## **$V_{CC}$ vs System Speed of MSP430F23x0**

### **ABSTRACT**

This document provides analysis details and specific results of the CPU45 errata affecting the following devices:

**Figure 1. Recommended Operating Conditions for System Frequency vs Supply Voltage**

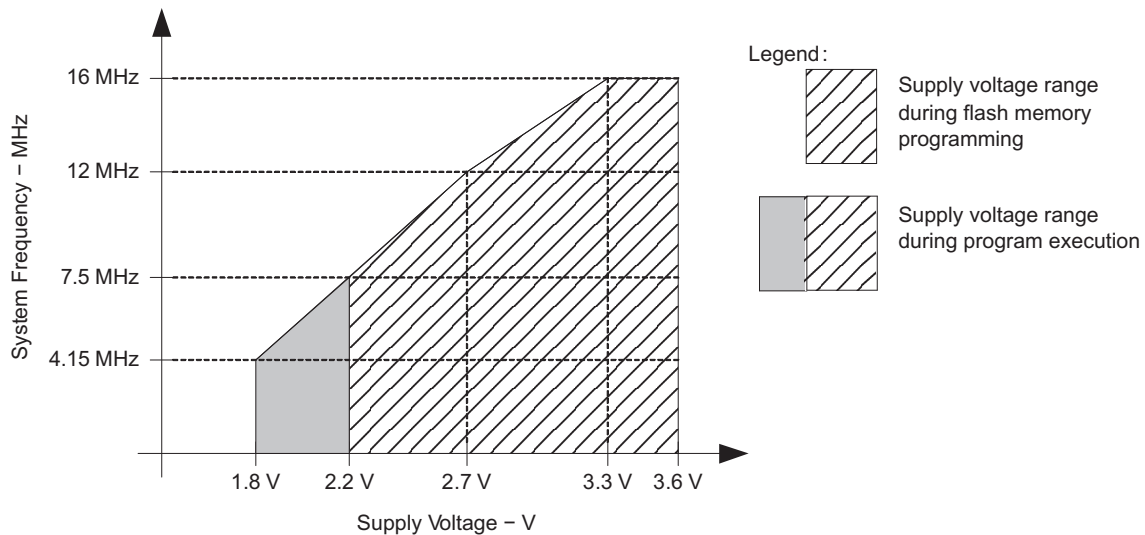
The system speed performance above 4.15 MHz versus minimum required  $V_{CC}$  as shown in [Figure 1](#) from the data sheet can be met under certain specific conditions only. If these conditions are not fulfilled, the CPU status register and R4 through R15 register contents may become unintentionally changed during some CPU register operations. This behavior is dependent on voltage, frequency, and clock duty cycle with certain operand and instruction combinations. Such code sequences are common in C-compiler generated application code.

When a CPU register is affected, the resulting value in the CPU register cannot be predicted.

For positive clock duty cycles of 50% or higher, the data sheet operating conditions hold fully true. This condition can be met with external positive 50% or higher duty cycle clocks or when using the DCO.

Figure 2. V<sub>CC</sub> vs Frequency – Safe Operating Conditions for LFXT1 in HF Mode and for Digital External Clock Sources

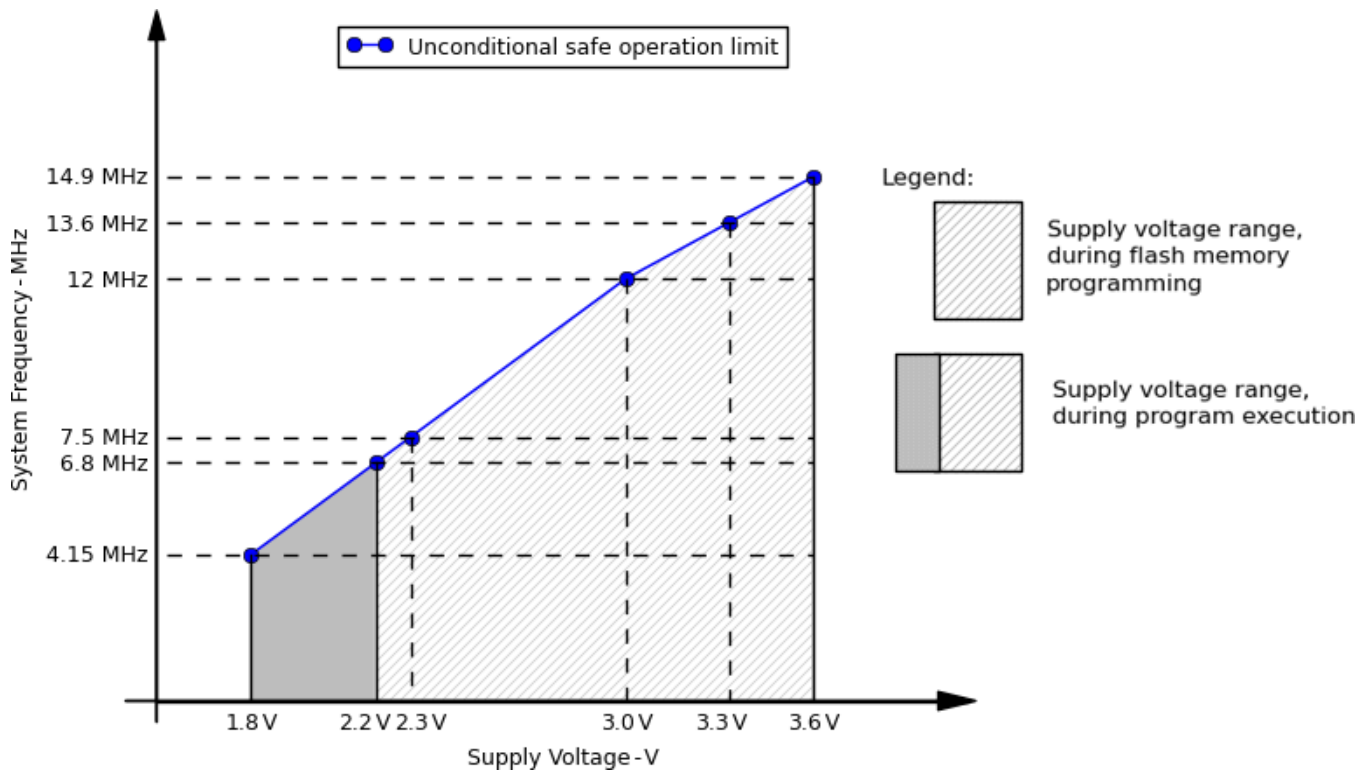
Figure 2 shows the safe operation area for the system clock (MCLK or CPU clock) when using an external clock or the device HFO without an internal clock divider.

- Use only the DCO as the clock source for the system frequency (MCLK or CPU clock).
- Reduce the system frequency (MCLK or CPU clock) according to the V<sub>CC</sub> vs frequency graph shown in Figure 2.
- Increase V<sub>CC</sub> according to the V<sub>CC</sub> vs frequency requirements as shown in Figure 2. Do not exceed the *Recommended Operating Conditions* as stated in the data sheet.
- Use internal dividers for the MCLK clock sources.
- Use external clock generators that provide a 50% or higher duty cycle.
